Service Bulletin

Bulletin No.: PIC5735A

Subject: Rattle Or Buzz From Behind IP IPC Or Dash

Models: 2013 Chevrolet Malibu
Equipped with 2.5L L4 Engine (RPO LCV)

Vacuum pipe contact.

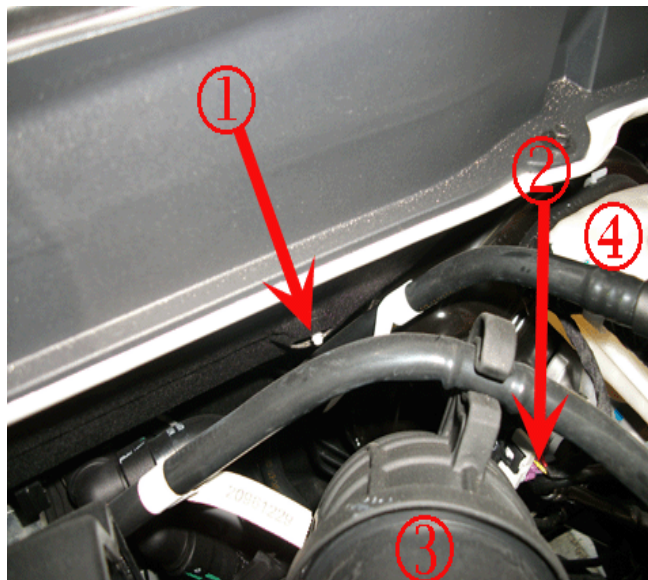
Inspect the plastic vacuum tube that supplies vacuum from the pump to the vacuum switch and brake booster. If either plastic tube is contacting the bulkhead, stud or brake lines continue with this repair. The vacuum pipe has likely been routed over the top of the throttle body and sensor during assembly. Remove the intake resonator and snorkel as shown below. Carefully flex the vacuum pipe rearward and off the throttle body and TPS. Pictures below indicate correct and incorrect routing. It may be necessary to wrap the brake booster vacuum switch with butyl tape if it is contacting a vacuum pipe. It may also be necessary to wrap the rubber section of the brake vacuum pipe with butyl tape if it is contacting a brake line or body of brake booster. See photo below for position of butyl tape on pipe. Check the position of pipe clamps for contact with brake booster or brake lines and reposition as needed.

1. Vacuum pipe contact with bulkhead and stud.
2. Vacuum pressure switch connector.
